Work Order ID 159953

Item ID: D205-634-041 Accept ***N900040100*** Setup Start ***NS1***
 Revision ID: Stop ***NS2***
 Item Name: Replacement Skidtube with Standard Wearplates Fits LH or RH
 Start Date: 4/24/2017 Start Qty: 1.00 ***1*** Cust Item ID:
 Required Date: 5/3/2017 Req'd Qty: 1.00 ***1*** Customer:
 Reference: SCHEDULED/S

DESIGN	DS	DART AEROSPACE LTD	
DRAWN	AJS	HAWKESBURY, ONTARIO, CANADA	
CHECKED	A.P.	DRAWING NO.	REV. G
MFG. APPR.		D2580	SHEET 2 OF 9
APPROVED		TITLE	SCALE
DE APPR.		205 SKIDTUBE ASSEMBLY	NTS
DATE	14.04.09	COPYRIGHT © 1996 BY DART AEROSPACE LTD THIS DOCUMENT IS PRIVATE AND CONFIDENTIAL, AND IS SUPPLIED ON THE EXPRESS CONDITION THAT IT IS NOT TO BE USED FOR ANY PURPOSE OR COPIED OR DISSEMINATED TO ANY OTHER PERSON WITHOUT WRITTEN PERMISSION FROM DART AEROSPACE LTD.

D2580-041 ASSEMBLY DETAIL

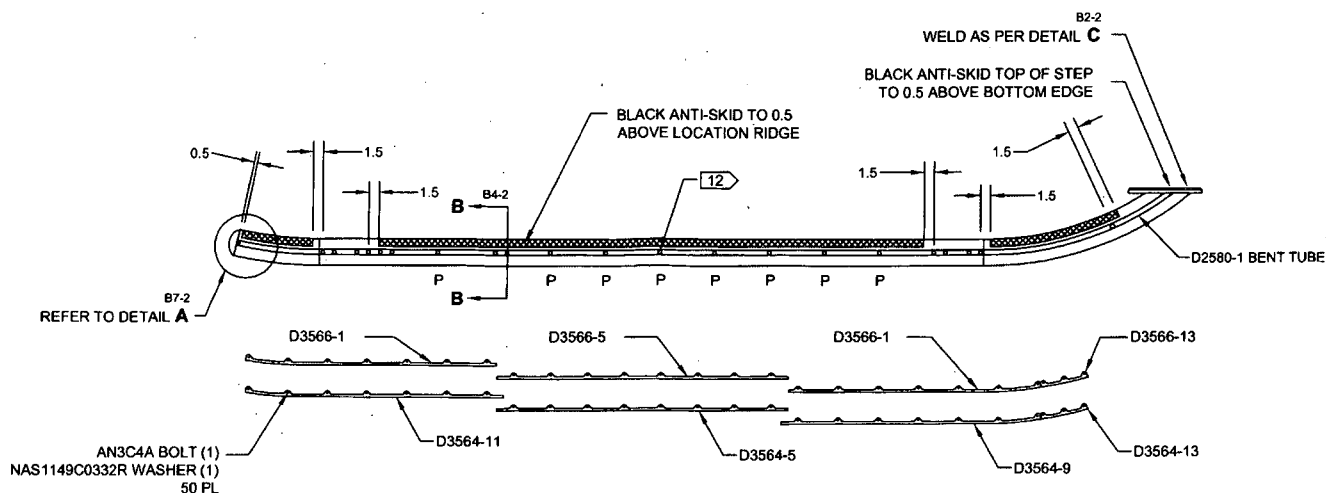
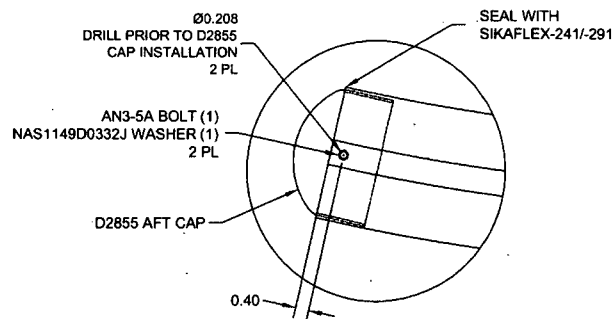
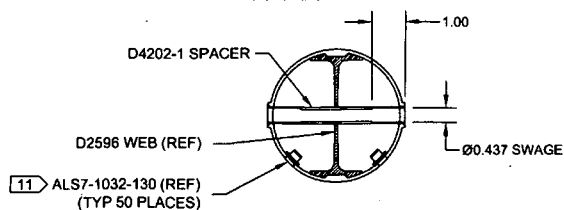
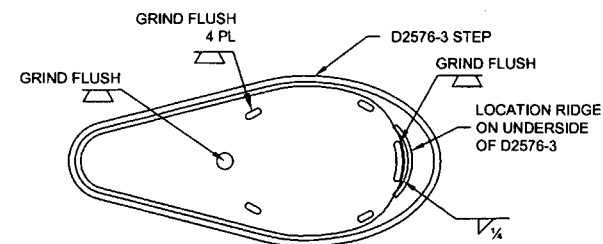
D3564-X wearplates no longer require gaskets, they now have textured coating.

Do not install D3566-X gaskets.

D2580 will be ~~not~~ updated to correct omission.

Kit is now CH9606
